Copper Flat Mine Draft EIS Evaluation

Comments from the Elephant Butte Irrigation District of New Mexico

To the U.S. Bureau of Land Management, Las Cruces
District Office.

March 4, 2016

Figure 2. Approximate Watersheds and Arroyo in Mine Area

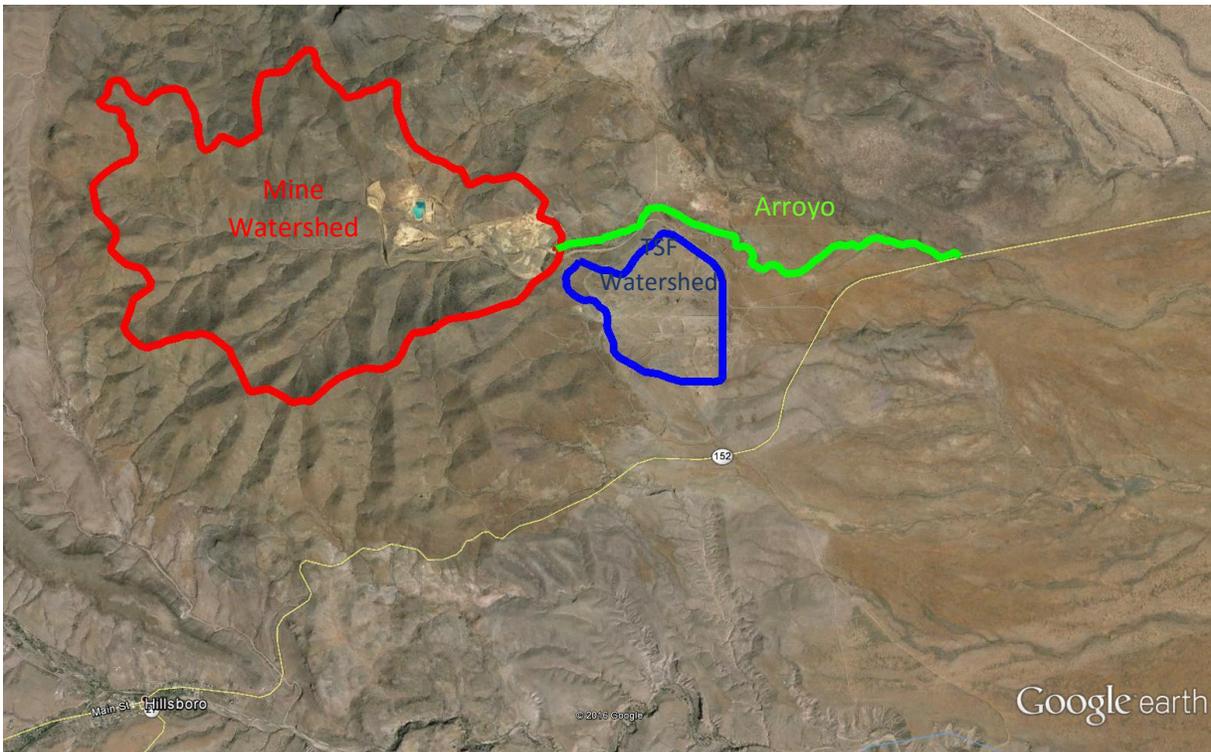
However, EBID recommends assessment of two separate watersheds²:

- 1) The upper watershed above the new mine facility (shown approximately in red in Figure 2)
- 2) The lower watershed at the TSF itself (shown approximately in blue in Figure 2)

The draft EIS does not present, to EBID’s knowledge, an estimate of the watershed area above the proposed operations. EBID estimates that the watershed area above the new plant facilities site (based on arroyos shown on Google Earth) is approximately 4.75 mi² as illustrated by the red line in Figure 2. Assuming 100% runoff from a PMP event, the total (un-attenuated) runoff volume is:

Because the upper watershed is a compact shape with high slopes the peak flow rate from a PMP on the upper watershed is anticipated to be very high and could generated volumes of water close to the value shown above. It appears that the upper watershed has not been a consideration because an arroyo is located below the new plant facilities site and north of the proposed new TSF (see green line in Figure 2).

The topography available to EBID’s researchers indicates that normal runoff flows will be intersected by the arroyo (green line in Figure 2) and divert flows away from the TSF site. However, EBID is concerned future developments at the new plant facilities may fill the arroyo and allow high flows from the upper watershed generated by a PMP event to flood the new TSF jeopardizing its integrity. Copper laden sediments could, under this scenario, be transported to Caballo Dam under the PMP.

The area of the lower watershed (see blue line in Figure 2) is approximately 0.7 mi² located south of Gold Dust Road. The natural topography at the site has been modified by previous mining operations (Quintana Mine). The “watershed” for the new proposed TSF site is essentially the TSF site itself (assuming no external drainage area). The construction of a perimeter embankment that could contain the full PMP storm event does appear to be feasible, as indicated below.
